ADDENDUM #1

- A. Project Number: 2023-10835
- B. Project Title: Fleck Fuel Facility Replacement
- C. Project Location: STA Valley (Fleck) Service Center, 123 S Bowdish, Spokane Valley, WA 99206
- D. Agency: Spokane Transit Authority

1.4 REVISIONS/CLARIFICATIONS TO PLANS AND SPECIFICATIONS SECTIONS

OVERALL
ELECTRICAL SITE
PLAN

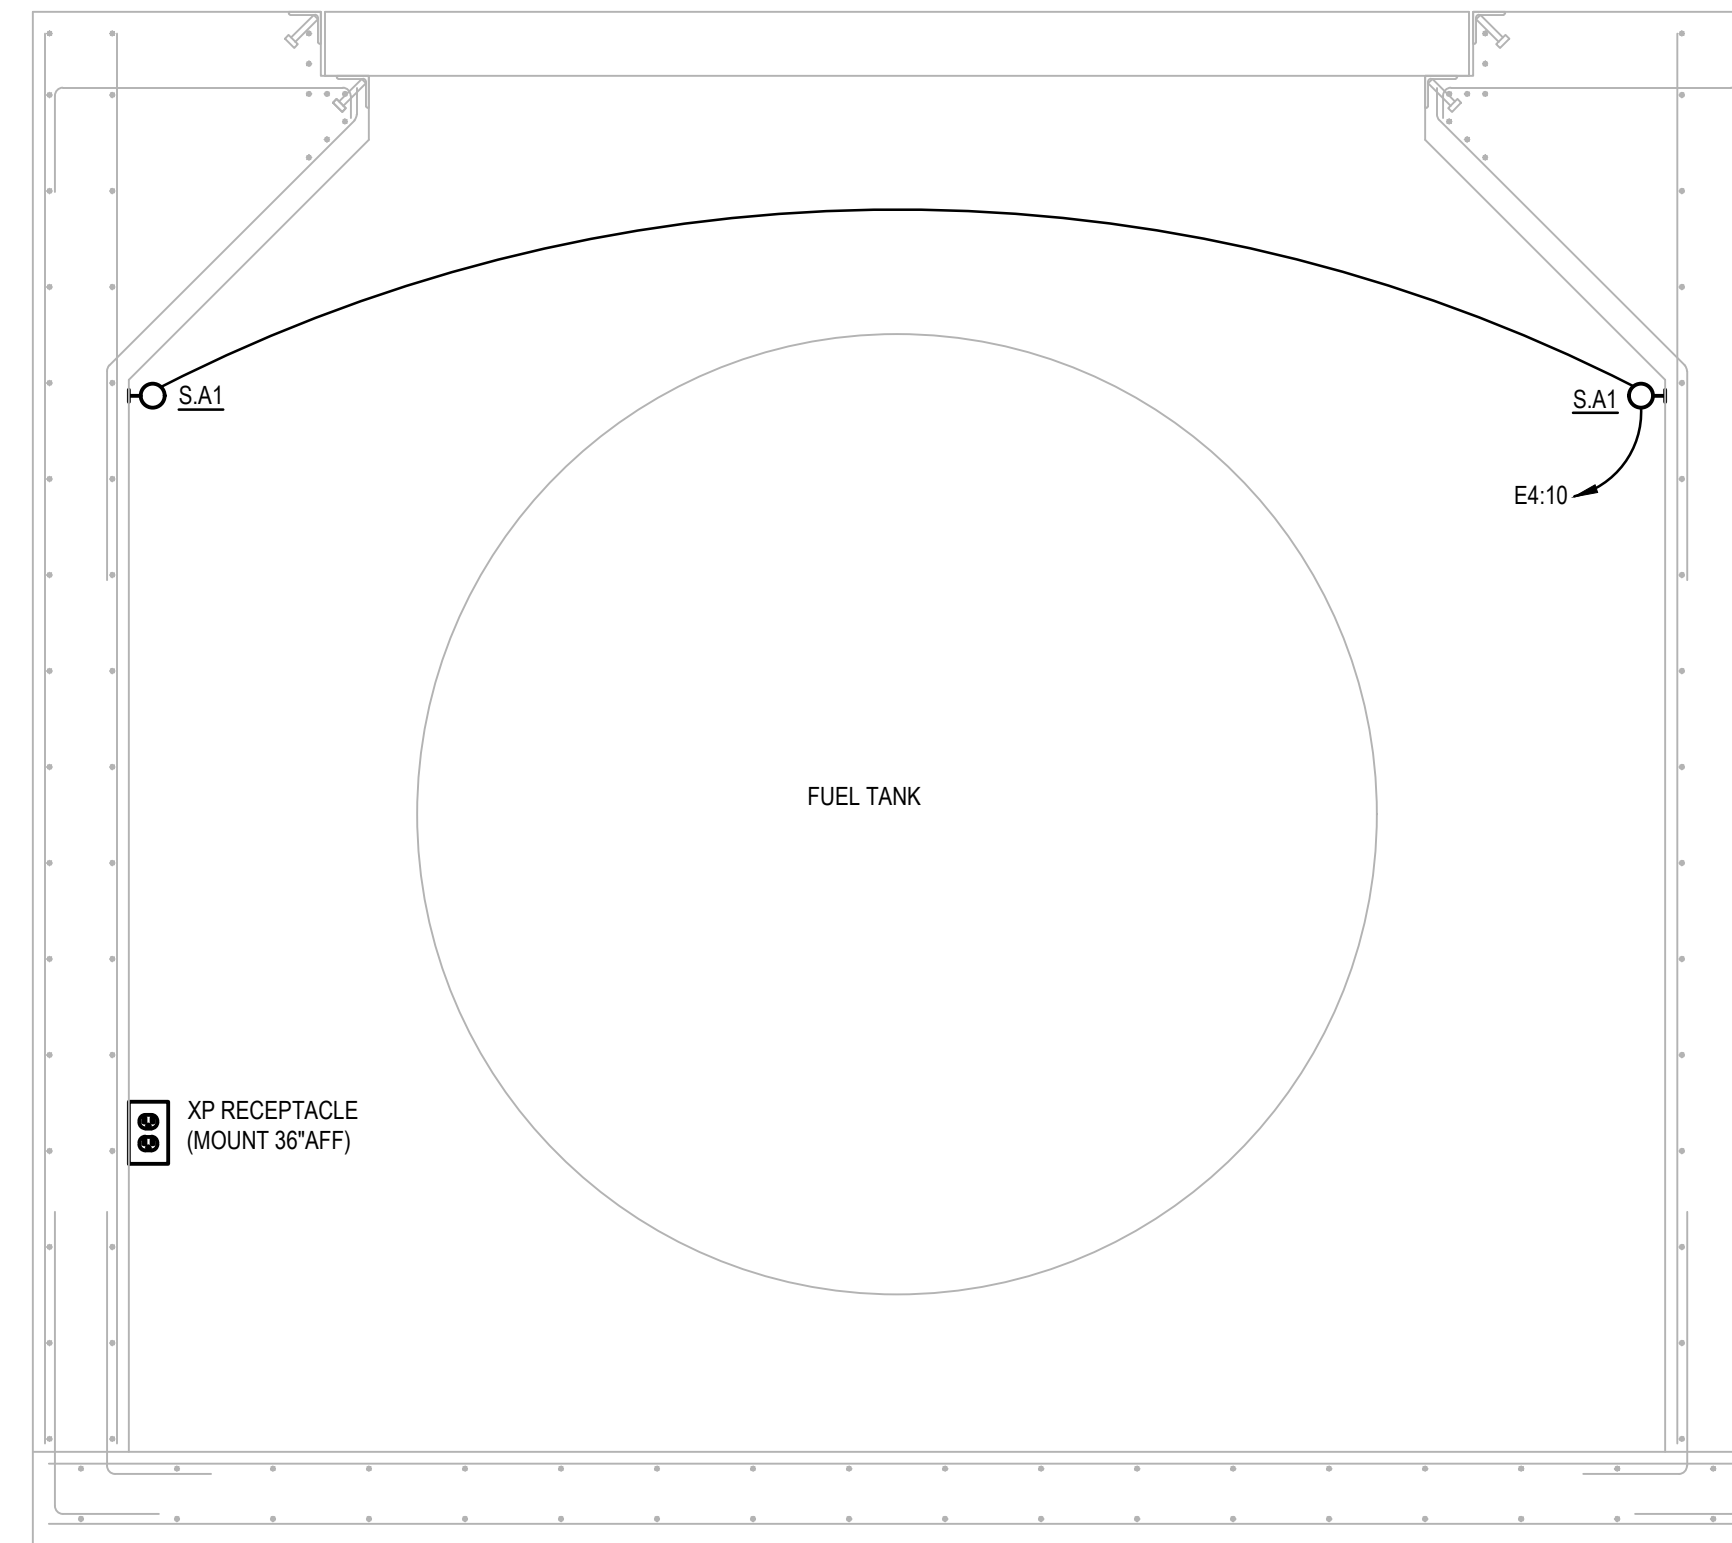
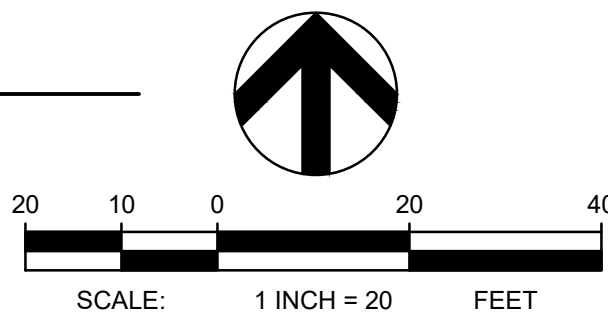
- A. **Sheet E-300 –**
Added code required convenience receptacle near exhaust fans.
General note and drawing changes for clarification.

ENLARGED PLANS - VAULT

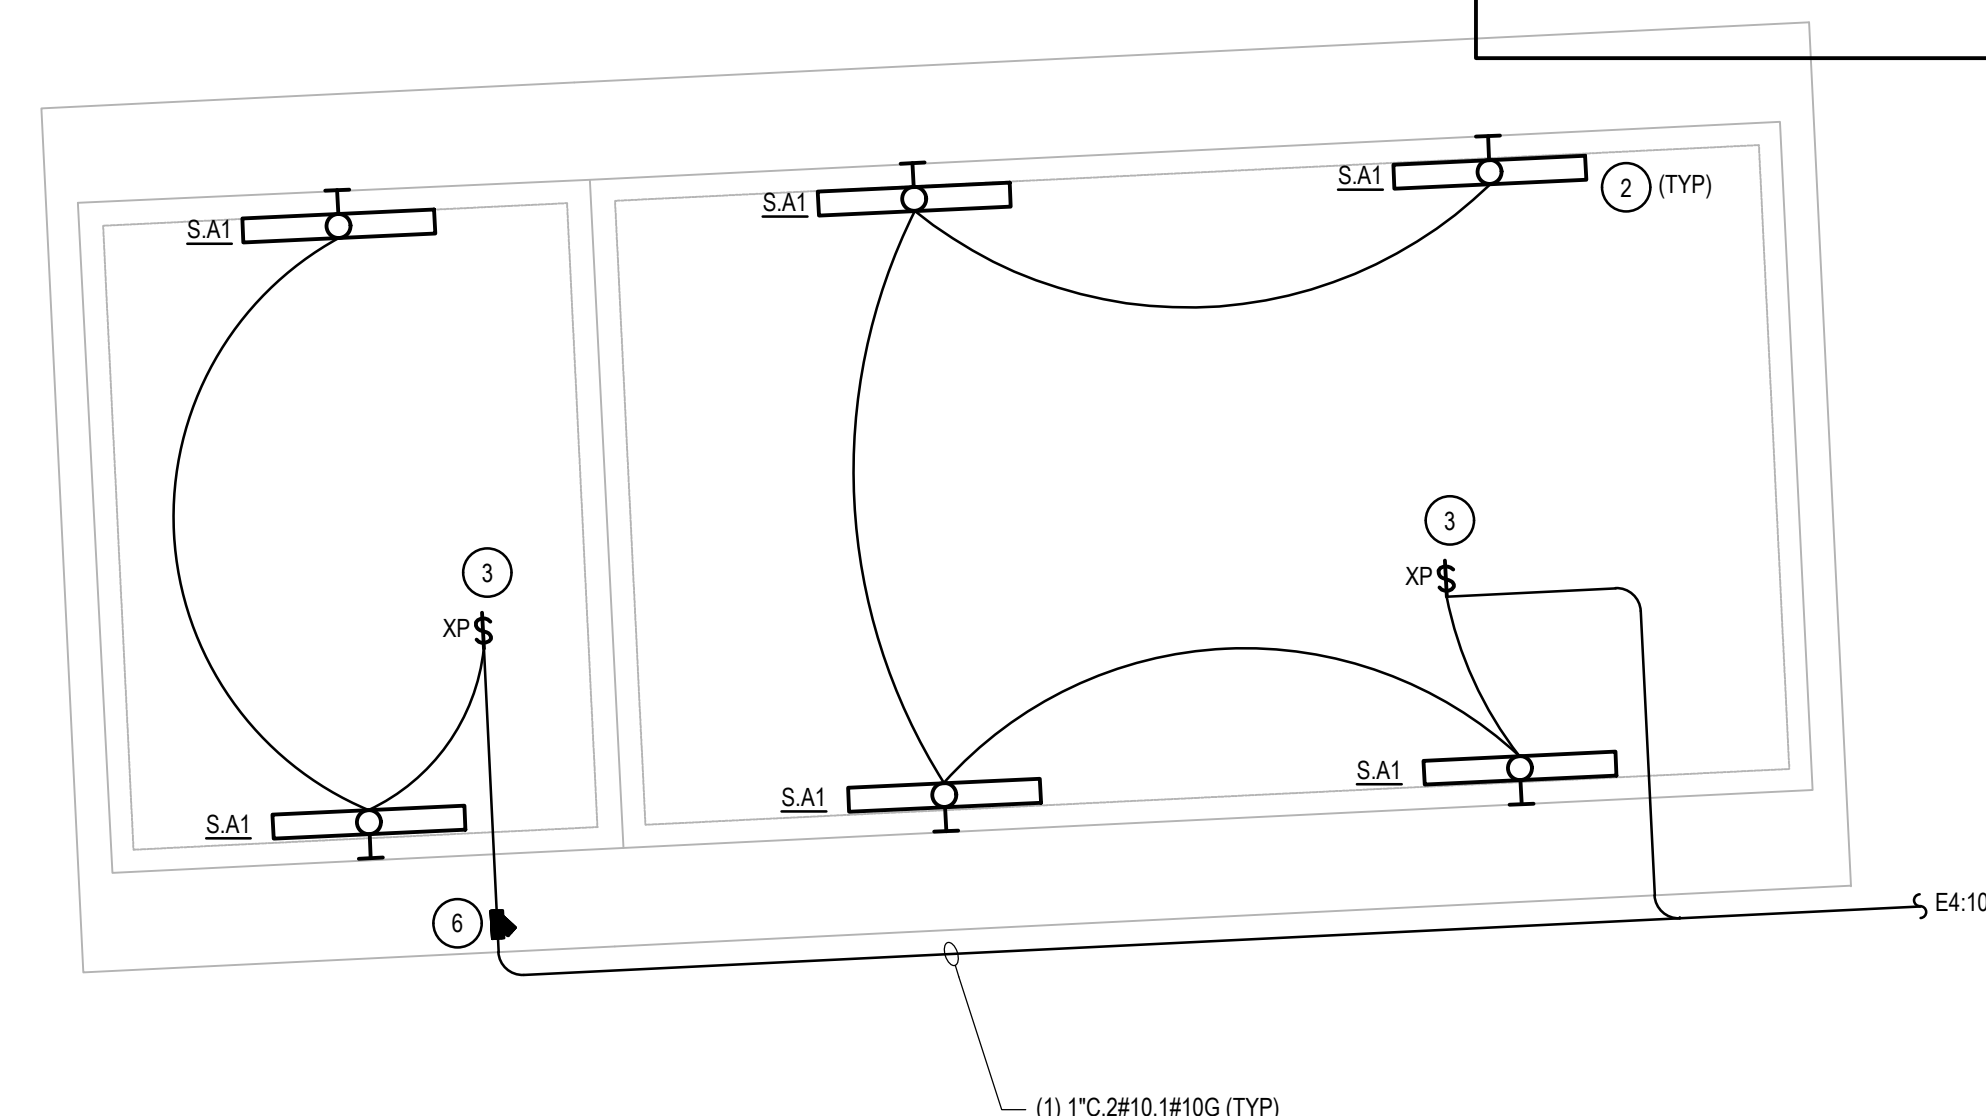
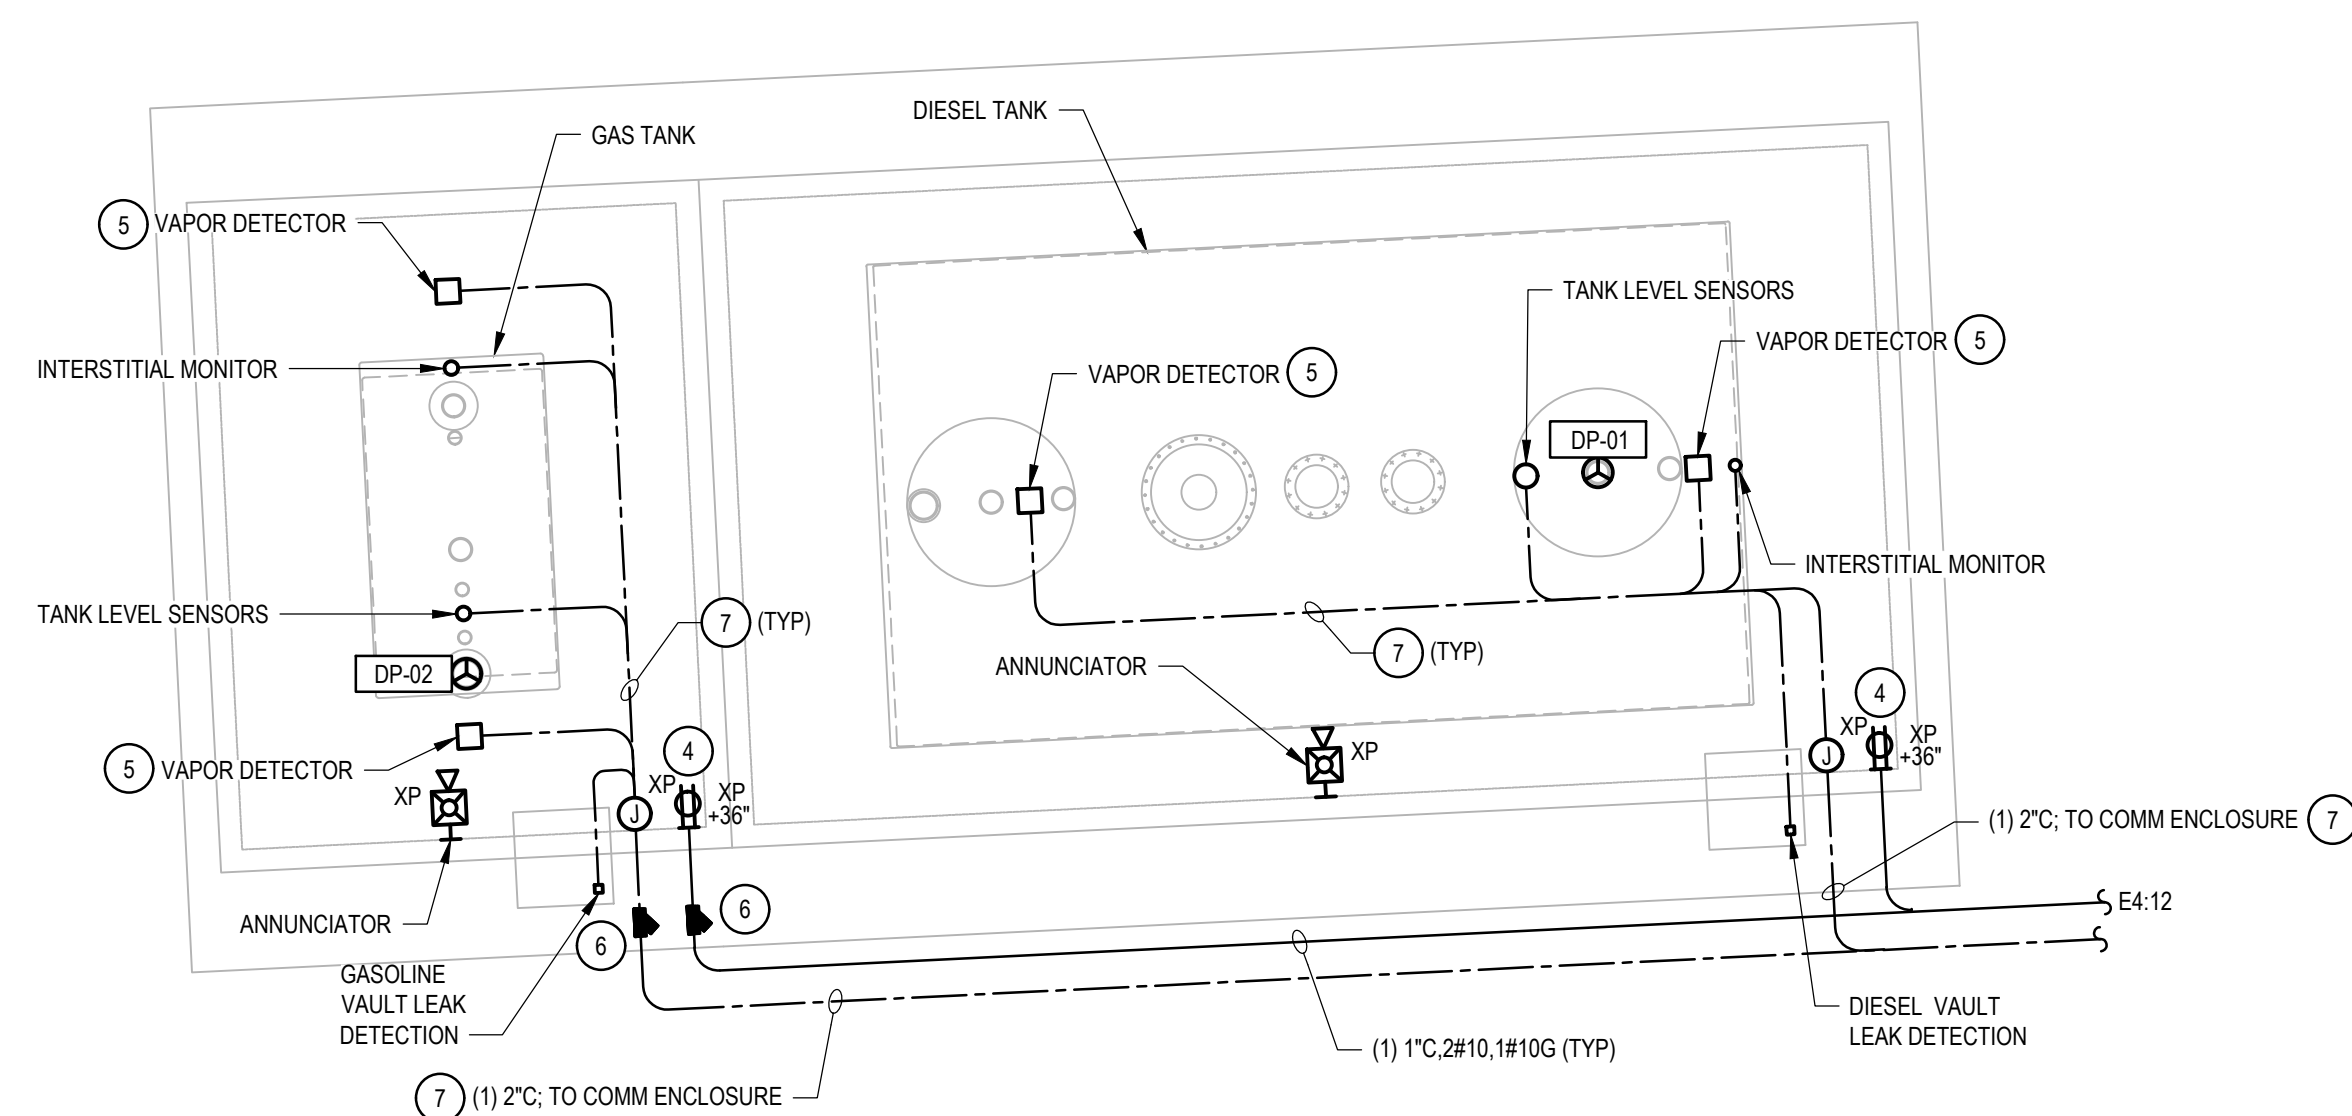
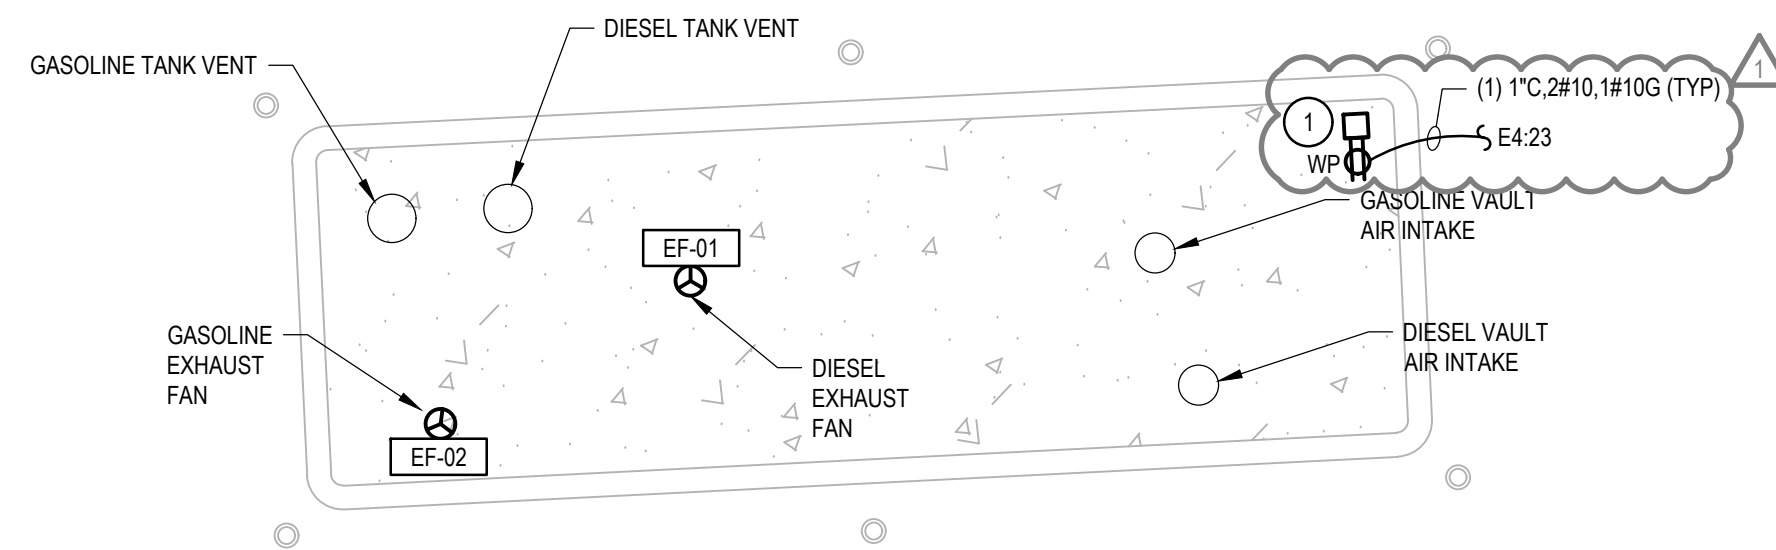
Sheet E-301 –
Added code required convenience receptacle near exhaust fans.
